ADDENDUM NO. 2

DATE: 05/07/26

PROJECT: Opstad Elementary School Parking Lot Expansion
Snoqualmie Valley School District

C1.00

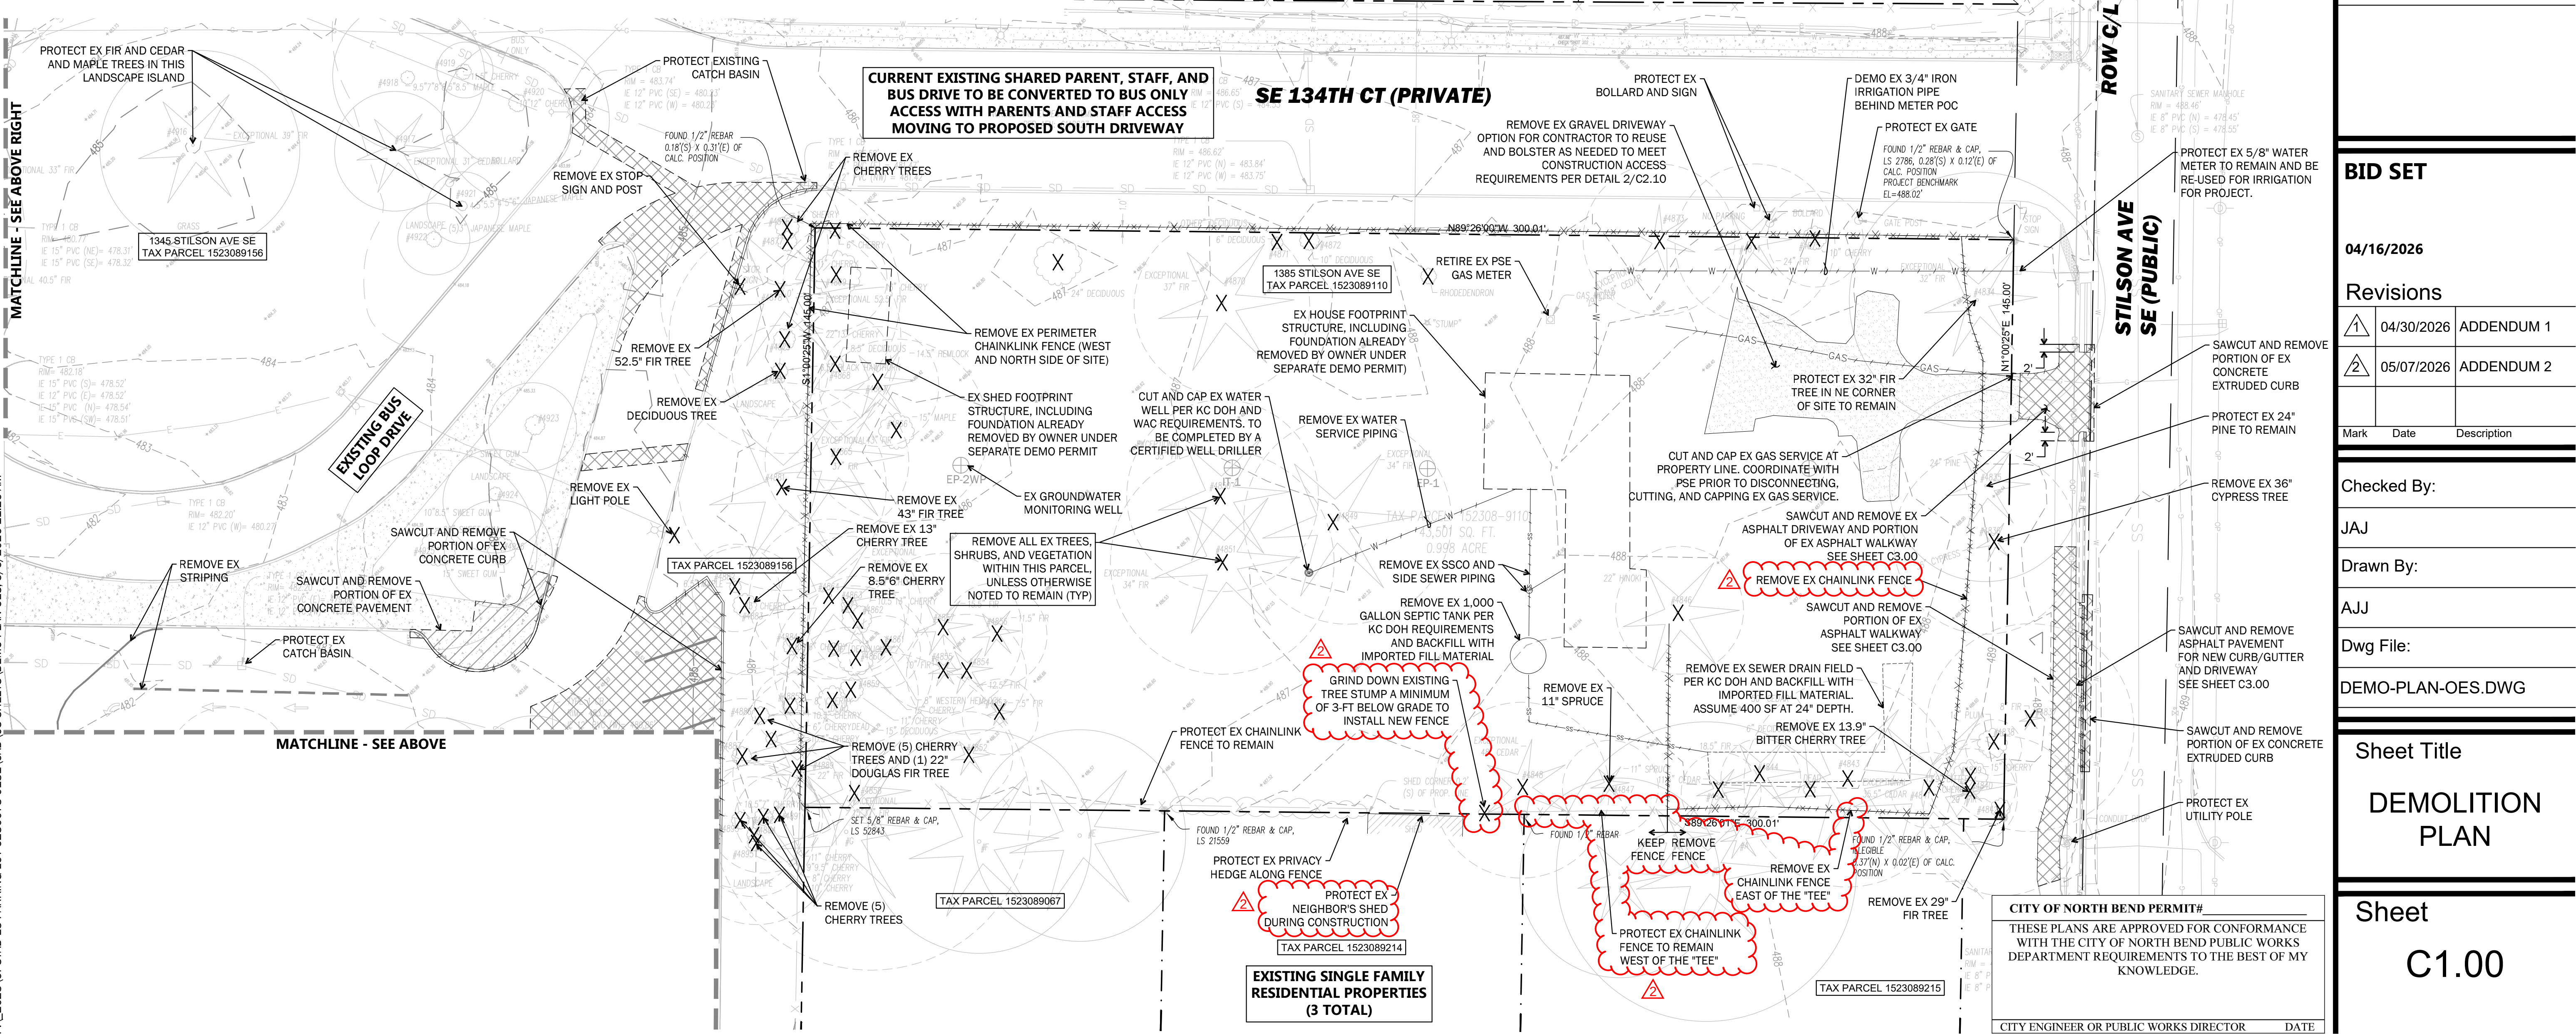
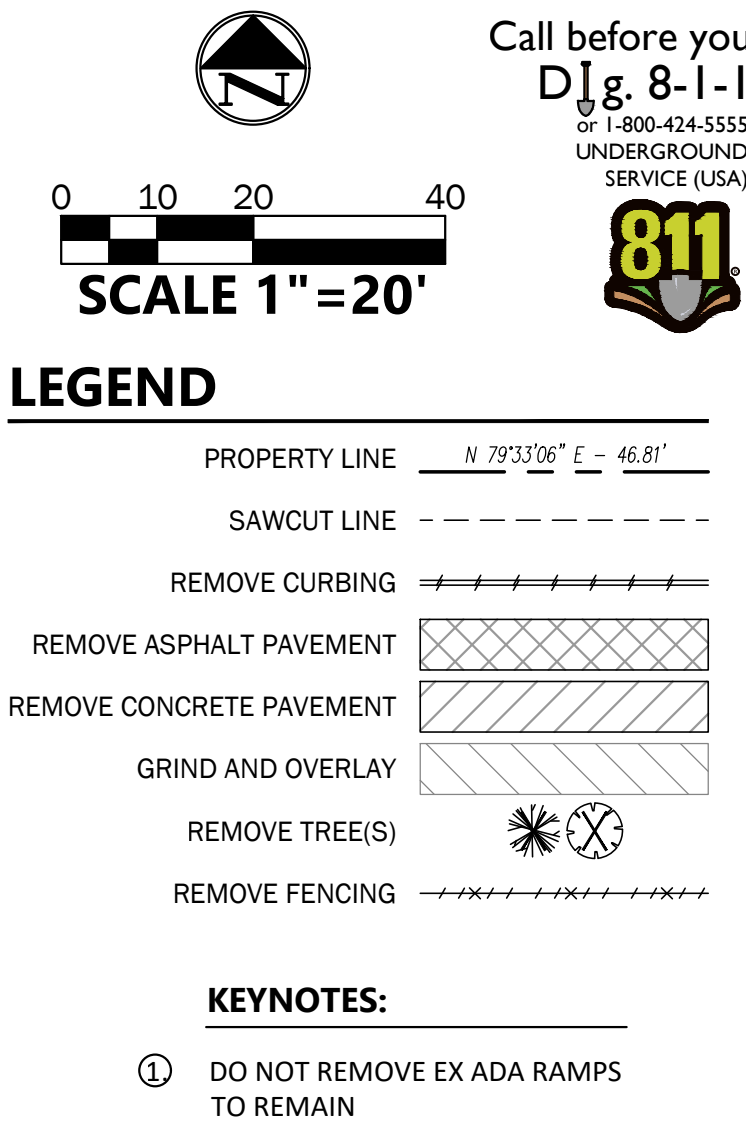
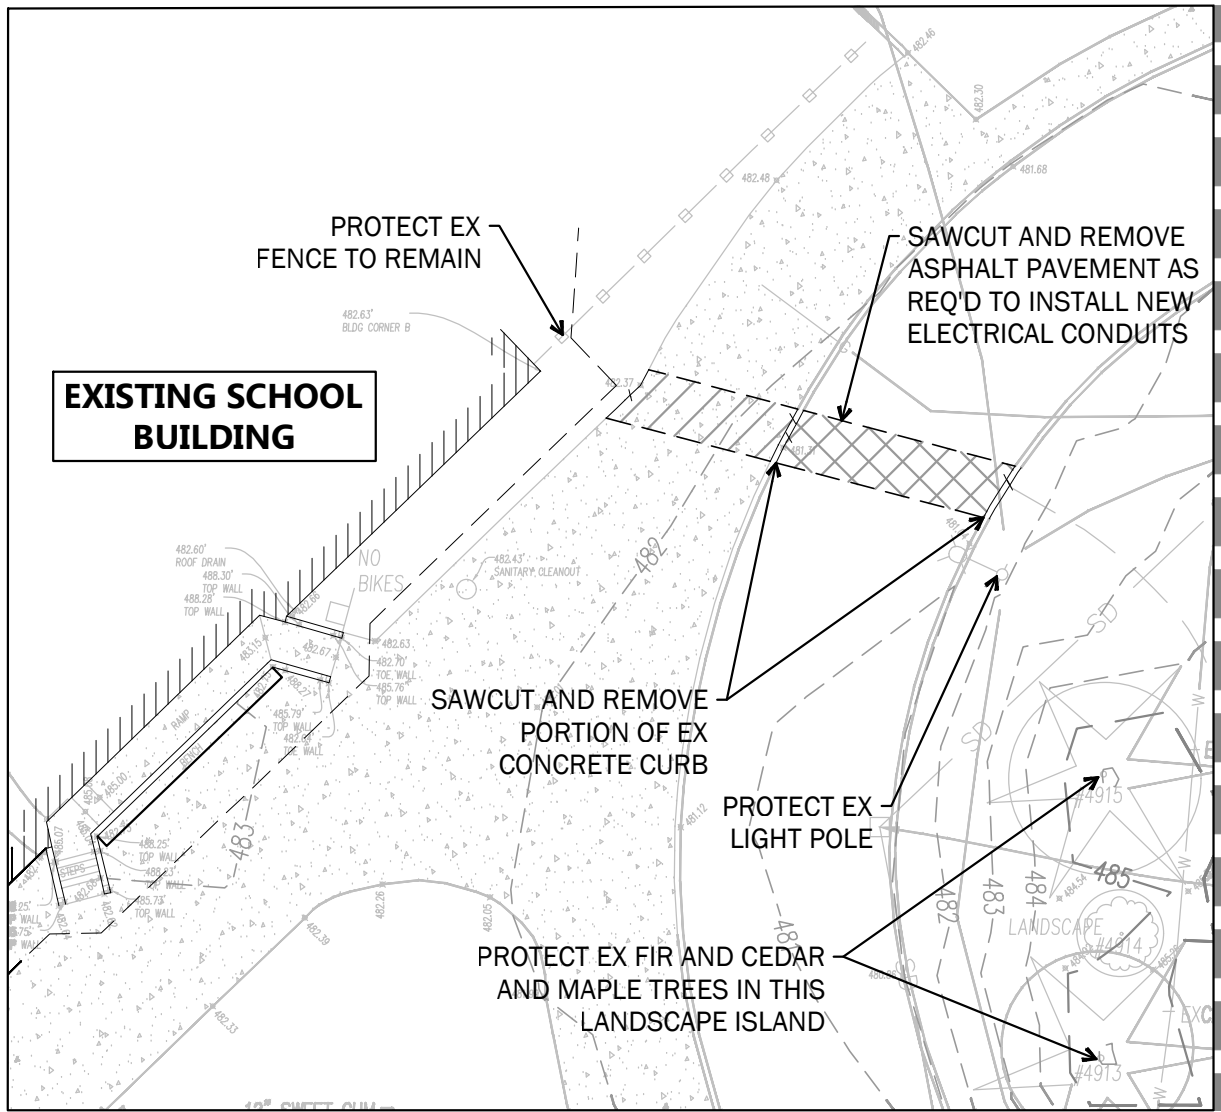
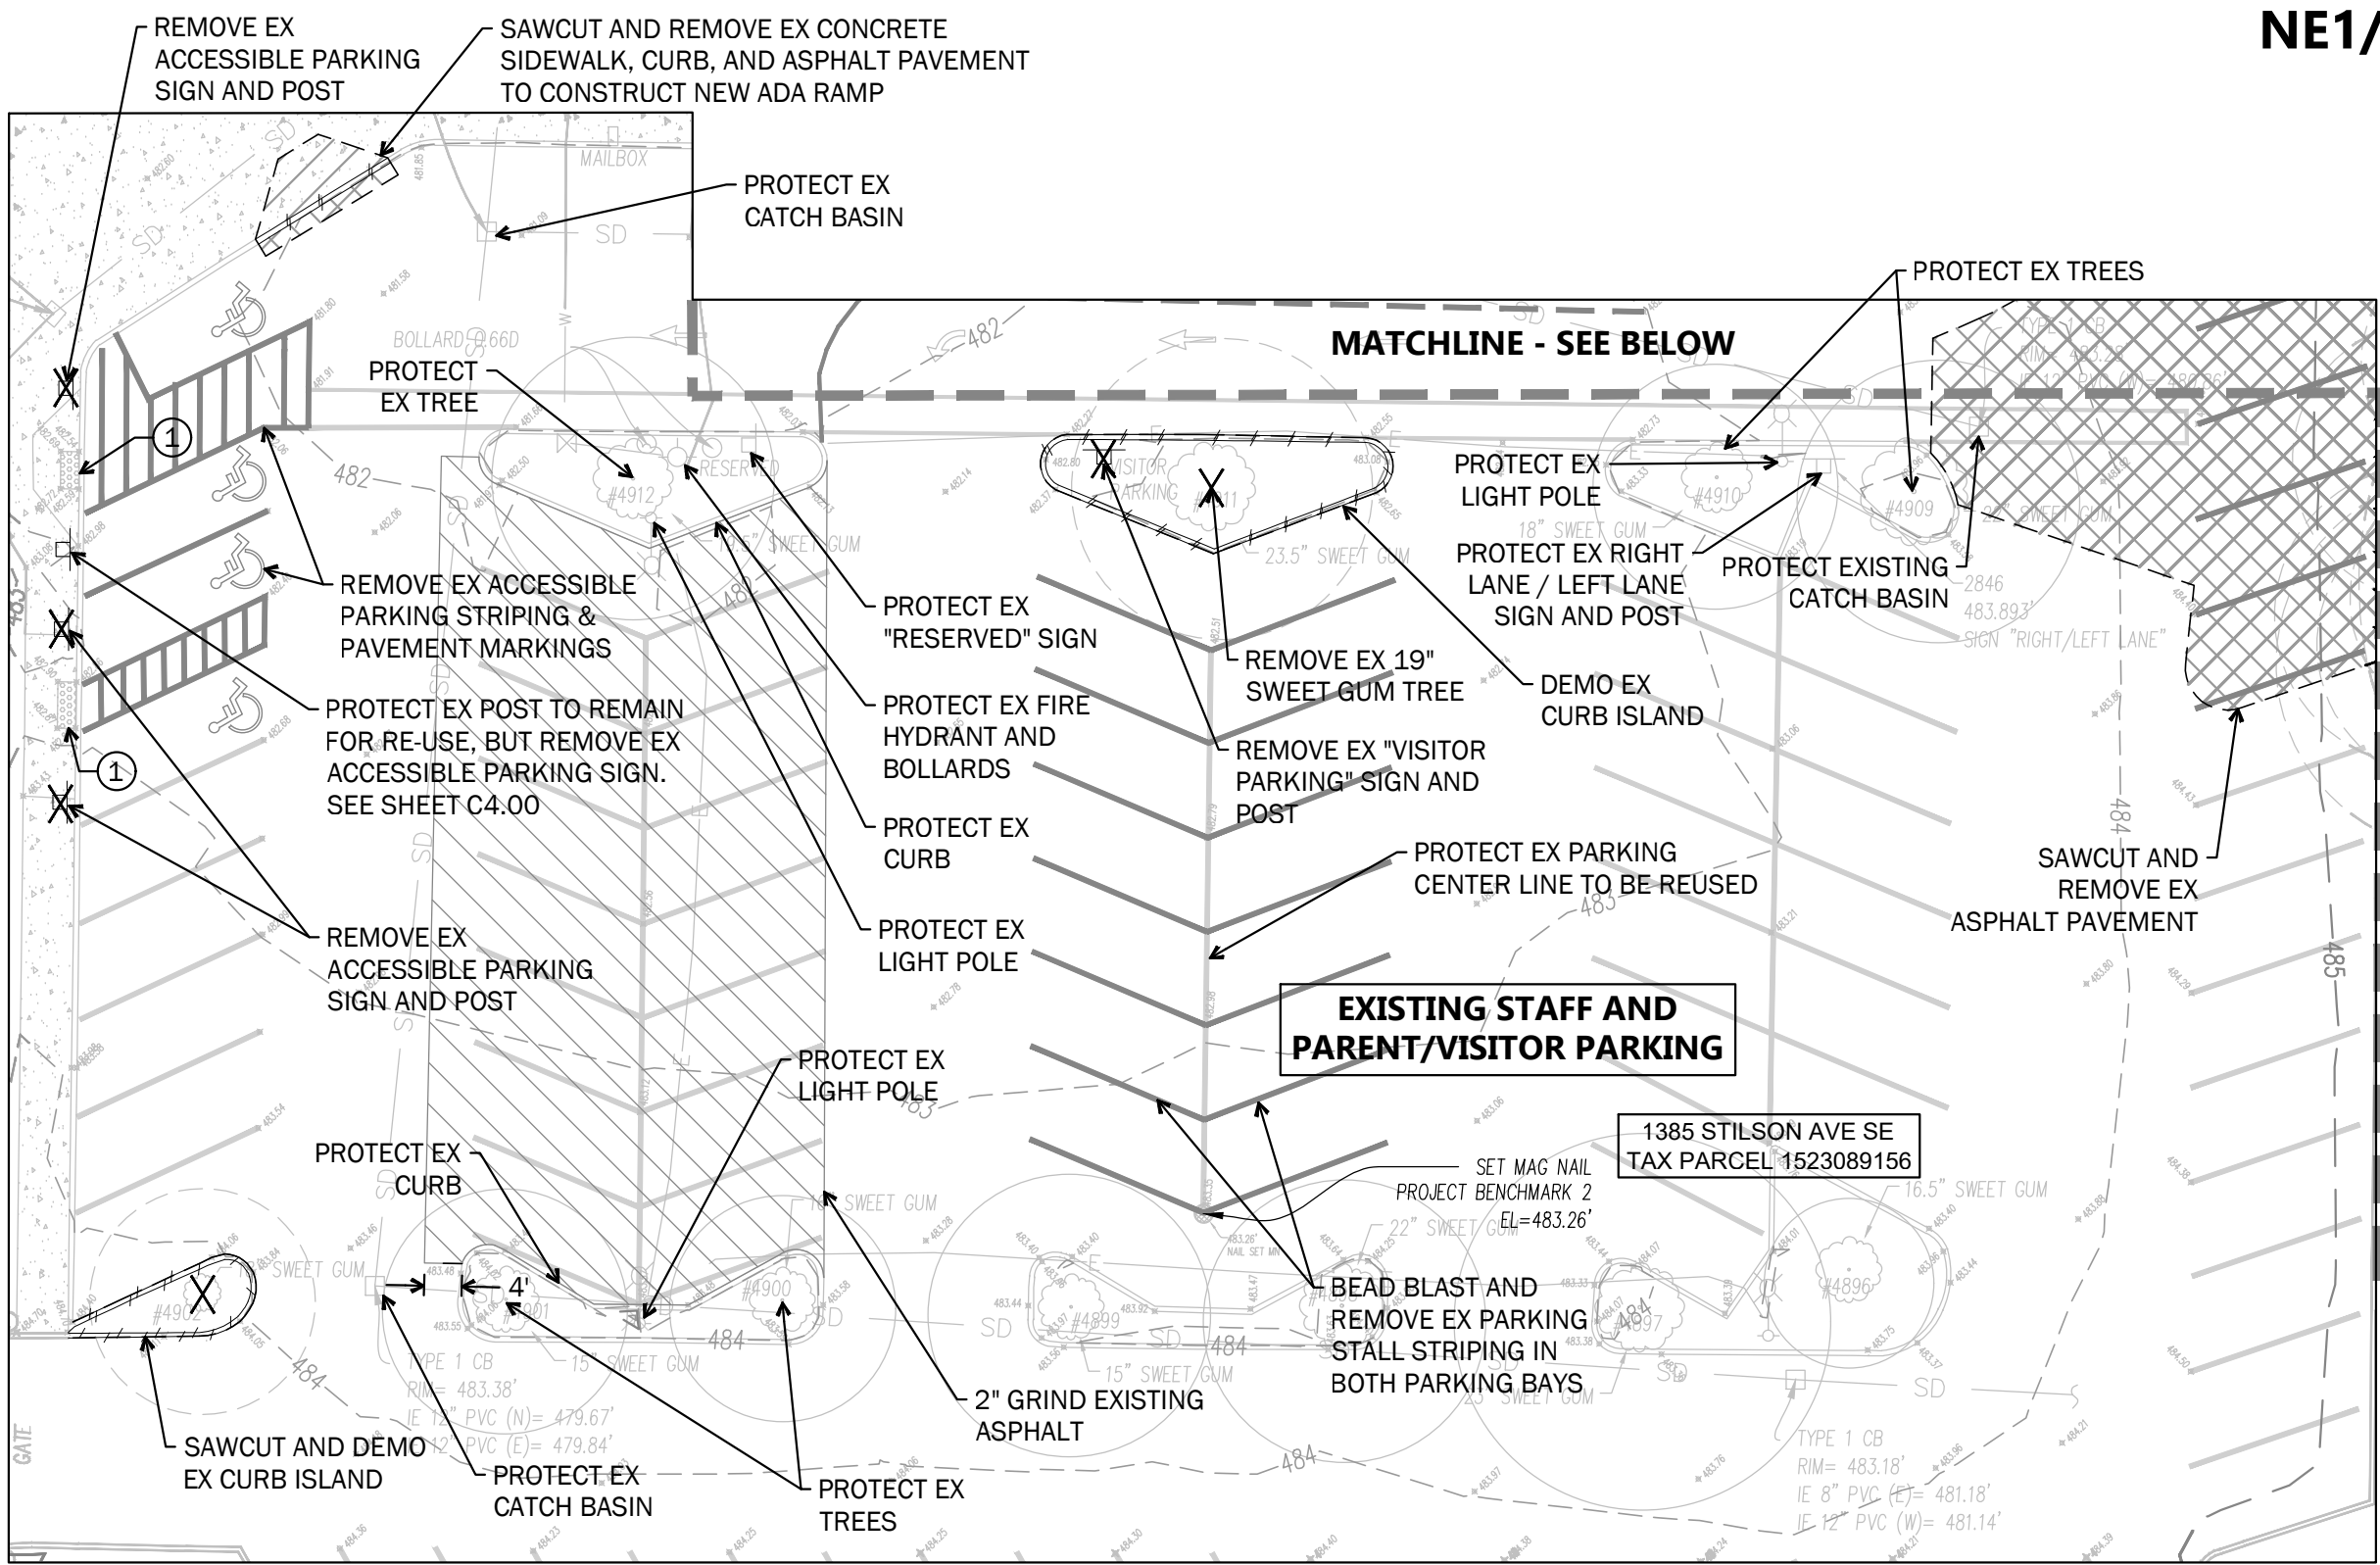
- Item #C01 SHEET C1.00 – DEMOLITION PLAN
ADD #02 A. **Revise** Demolition and Protection of existing chainlink fence along south property line as indicated on plan.
 B. **Add** note to “REMOVE EX CHAINLINK FENCE” for fence on east side of site for clarification; fencing shown as demolished line type but including note for clarity.
 C. **Add** Grinding of existing tree stump at roughly the midpoint of south property line between gap in fence and existing shed on neighboring property.
 D. **Add** note to “PROTECT EX NEIGHBOR’S SHED DURING CONSTRUCTION”.
- Item #C02 SHEET C3.00 – PAVING PLAN
ADD #02 A. **Add** Callout for “4’ High Black Vinyl Coated Chainlink Fence” for clarification; fencing shown on west side of parking lot but including note for clarity.
 B. **Add** NEW “4” High Galvanized Chainlink Fence” along south side of property line in SE corner of site as indicated on plan.
